Subject: AP1000 Response to Request for Additional Information (SRP TR44)

AP1000 TECHNICAL REPORT REVIEW

RAI Response Number: RAI-TR44-011
Revision: 2

1. APP-GW-GLR-026, Revision 0, May 2006, "New Fuel Storage Rack Structural/Seismic Analysis," (Technical Report Number 44, TR44)
2. Westinghouse Calculation APP-GW-S2R-010, Revision 2, May 2008, "Extension of NI Structures Seismic Analysis to Soil Sites" (Technical Report Number 3, TR03)
3. APP-GW-GLR-026, Revision 3, May 2010, "New Fuel Storage Rack Structural/Seismic Analysis," (Technical Report Number 44, TR44)
4. Westinghouse Calculation APP-GW-S2R-010, Revision 4, March 2010, "Extension of NI Structures Seismic Analysis to Soil Sites", (Technical Report Number 3, TR03)

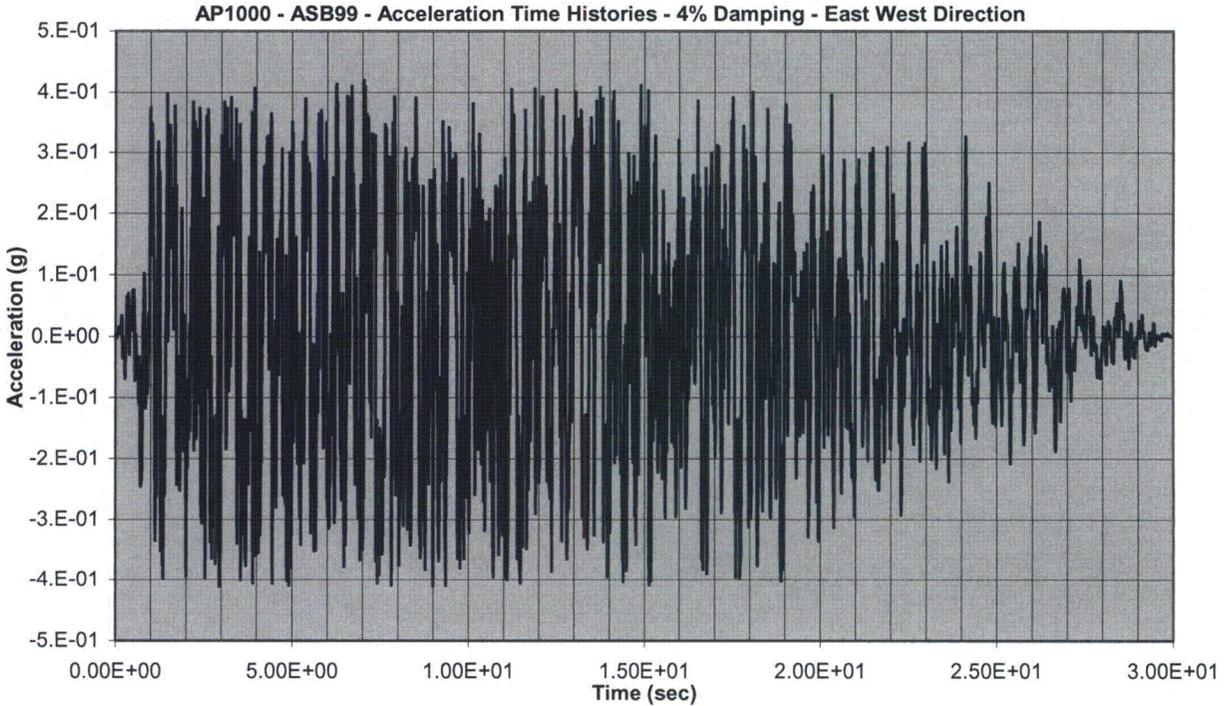
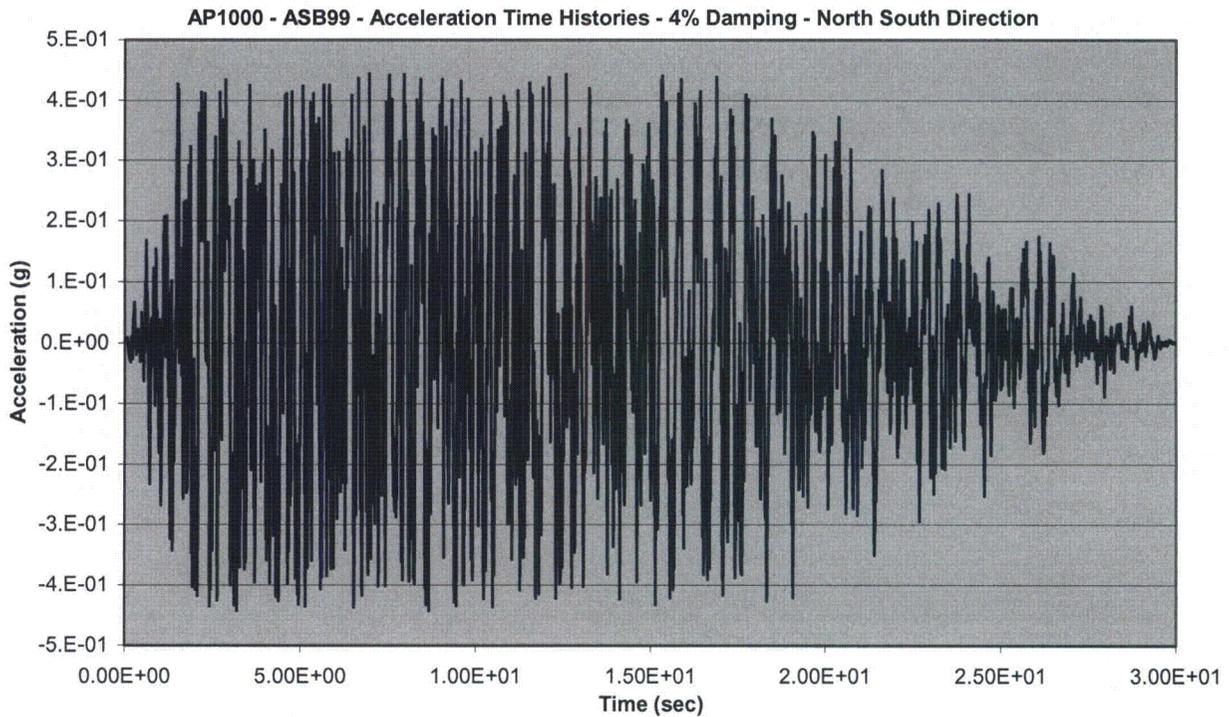
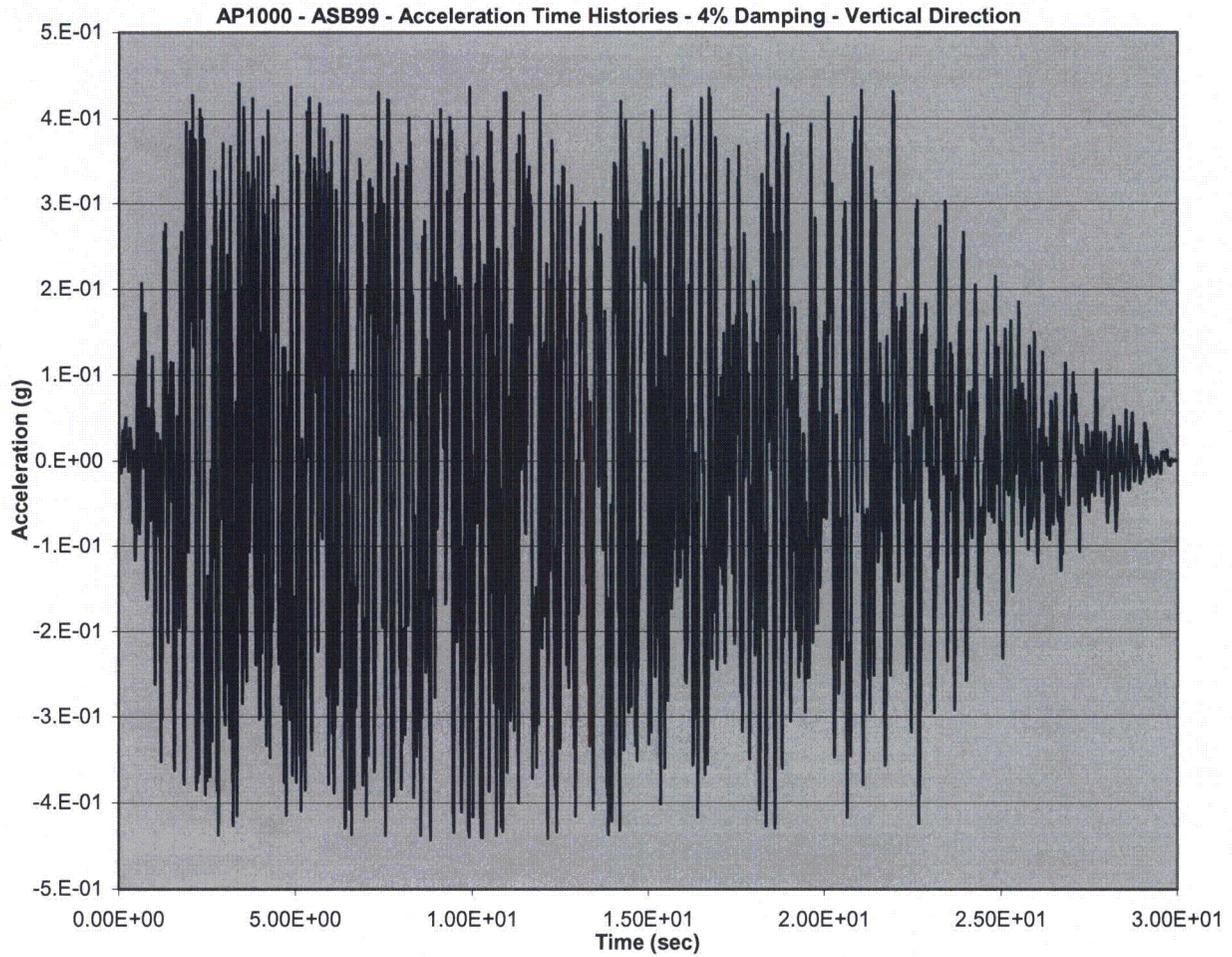
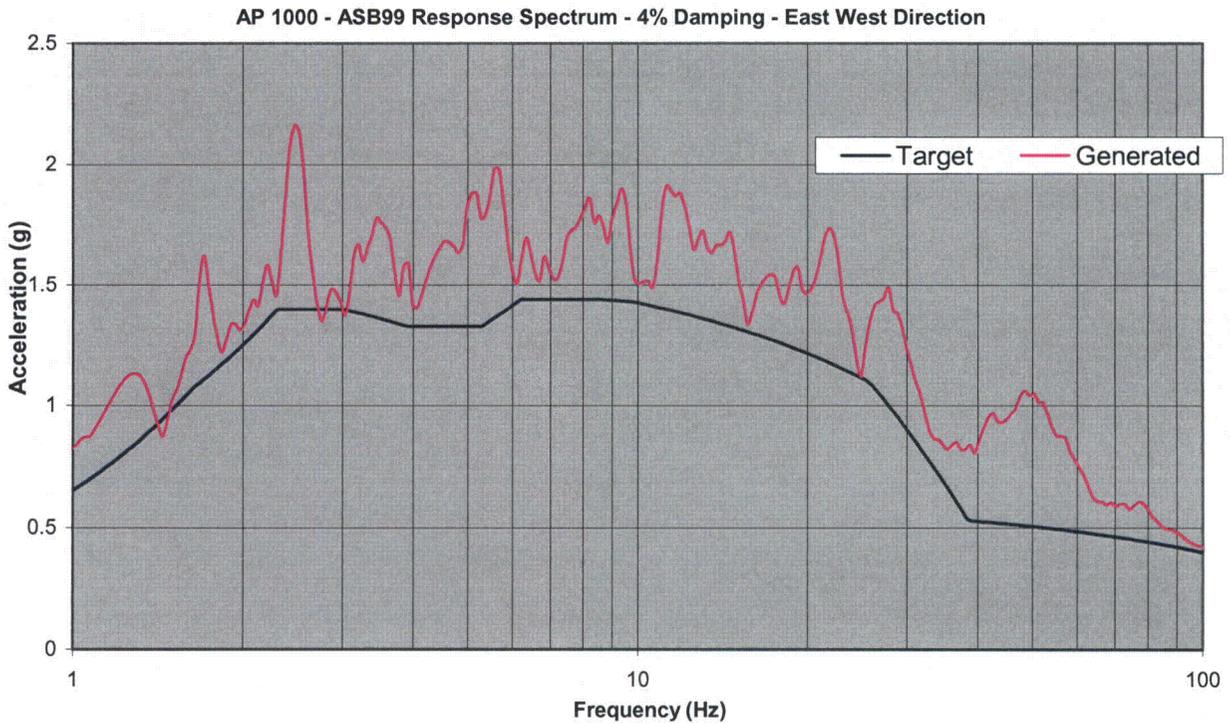
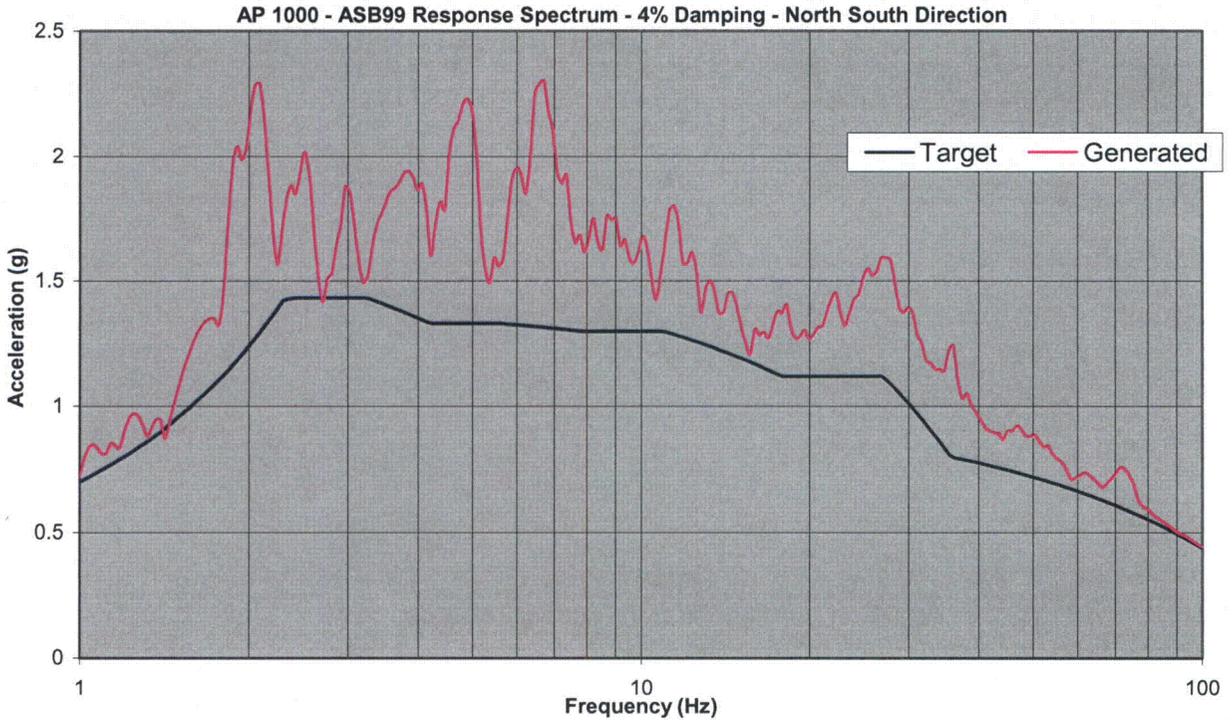
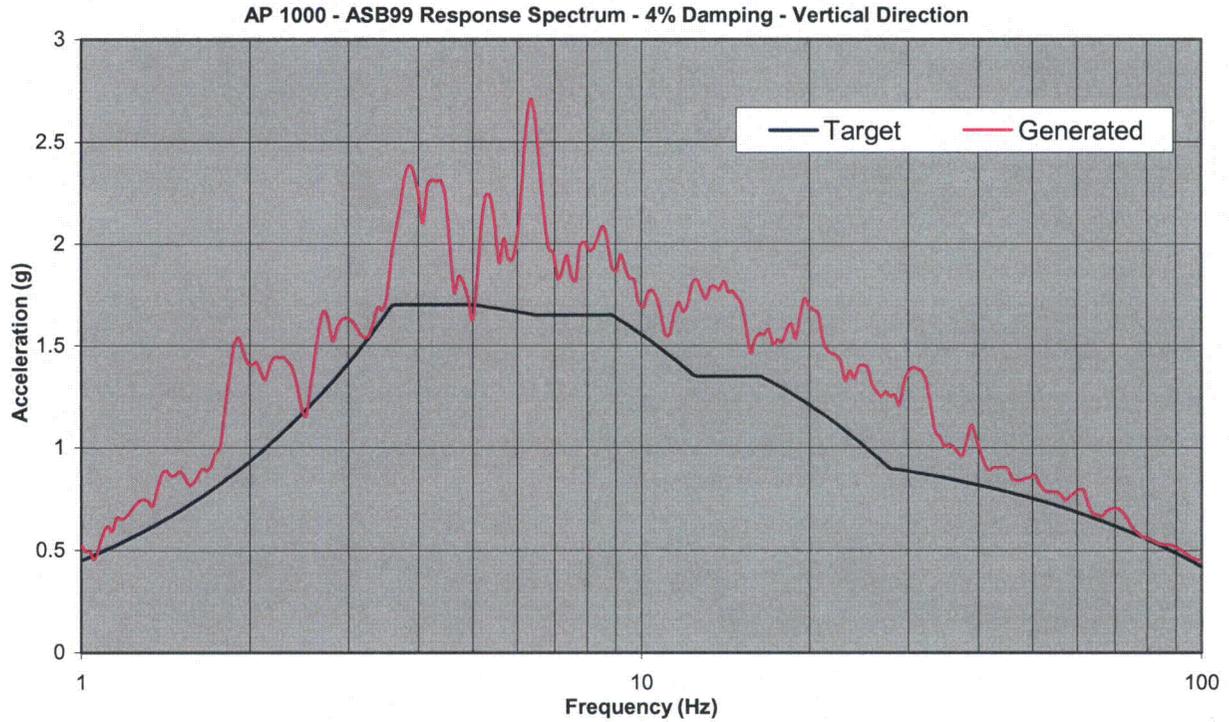
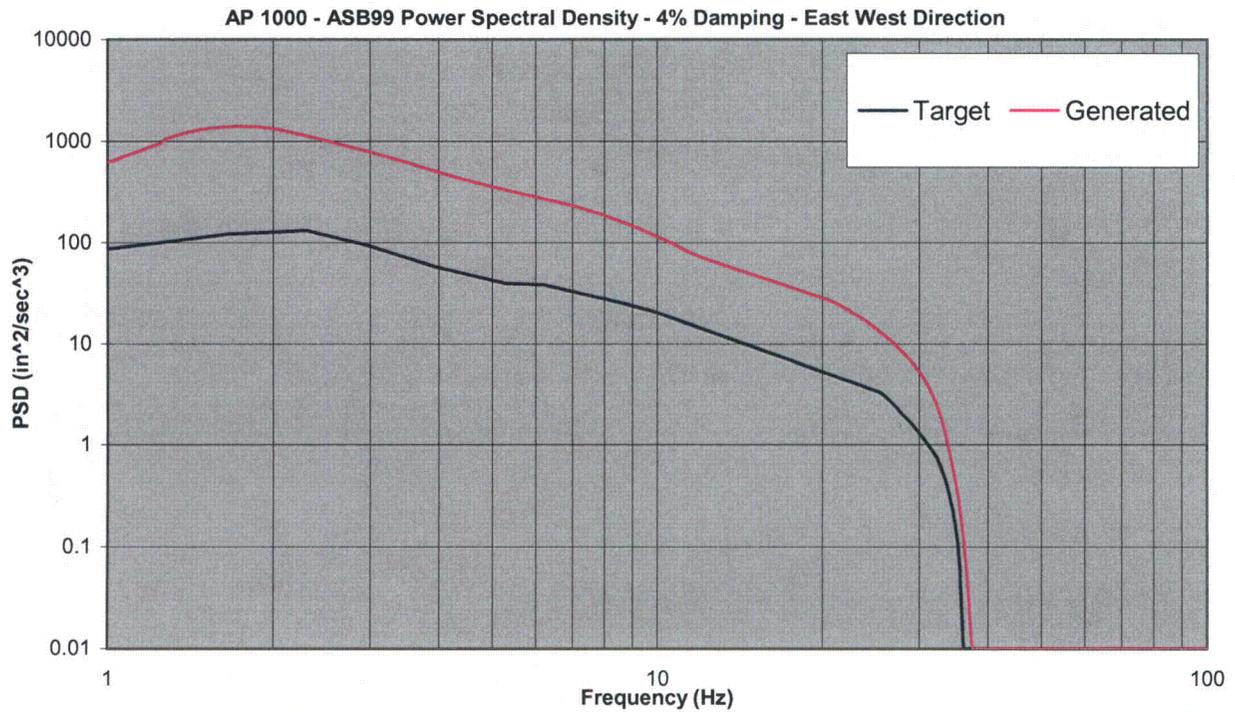
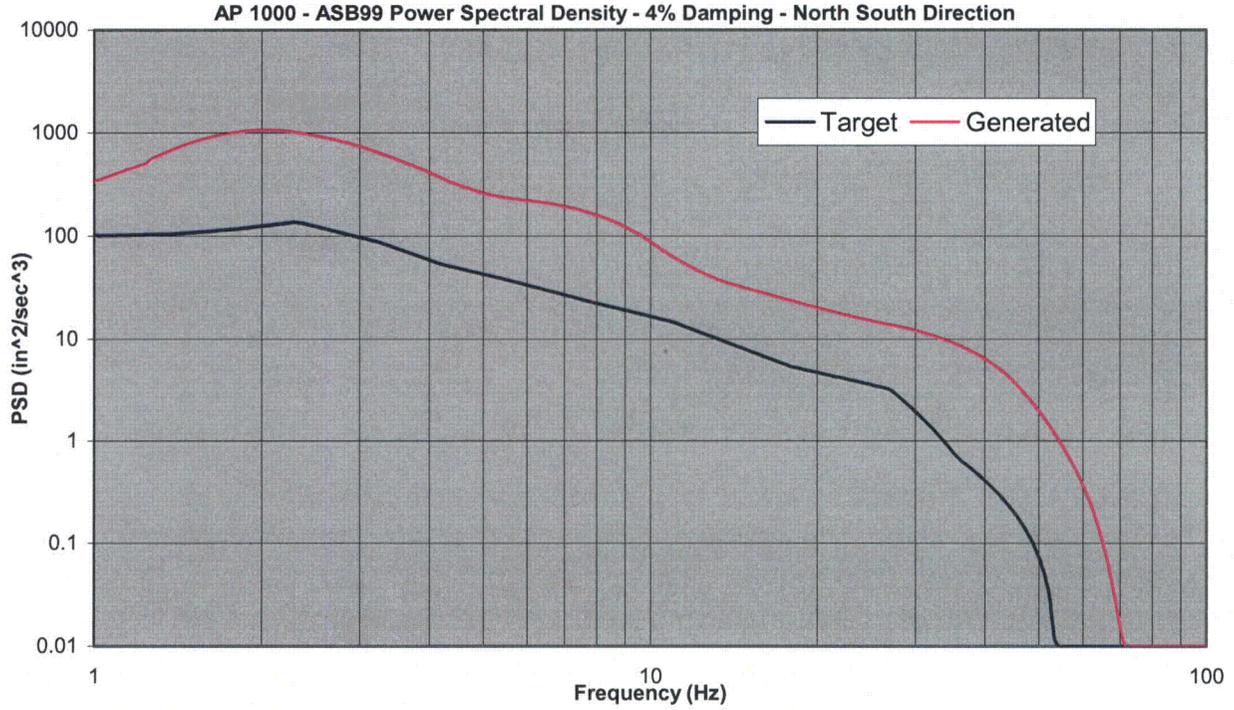
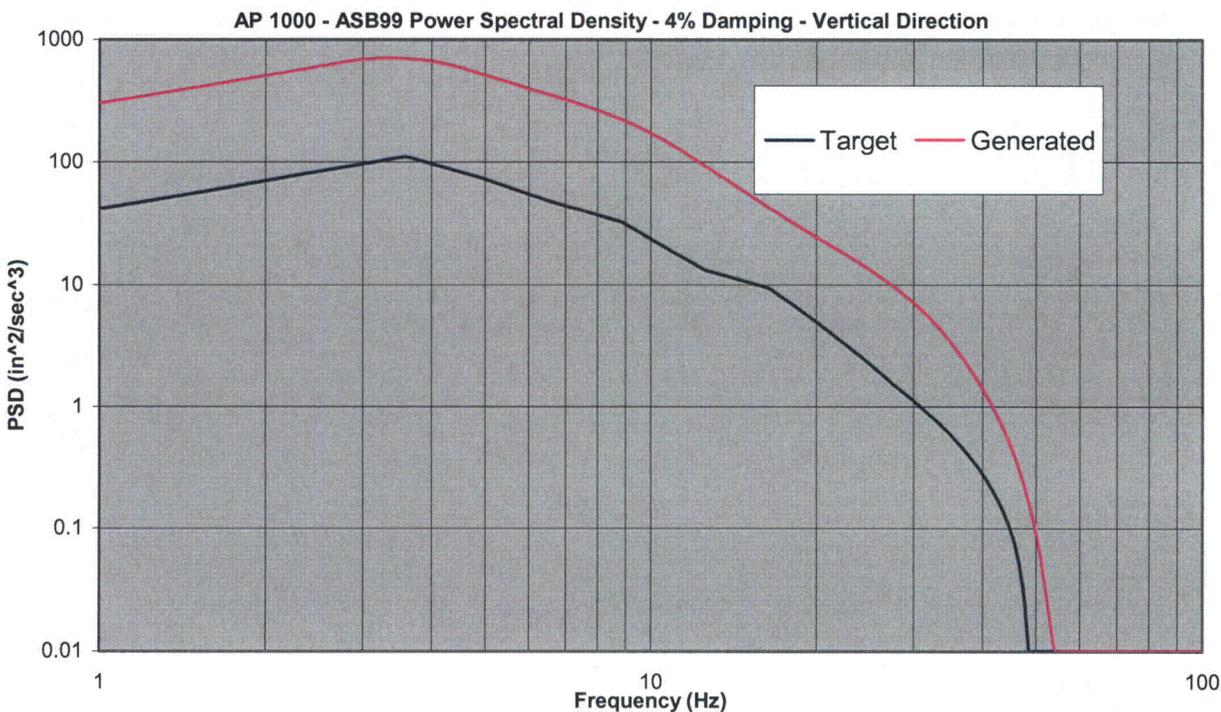
- (d) For the synthetic time histories, provide plots of the three time histories, the cross correlation coefficients, the comparisons of the spectra from the synthetic time histories to the enveloped target response spectra, and the comparisons of the power spectral density plots to the target power spectral density function associated with the target response spectra.

- d) The synthetic time histories, the response spectrum curves, and the power spectral density plots for the Auxiliary and Shielding Building (ASB) at Elevation 99 feet are provided in Figures TR44-11.1 through TR44-11.9. The cross correlation coefficients for the three orthogonal components (East-West, North-South, and Vertical) of the ASB99 synthetic time histories are summarized in the table below:
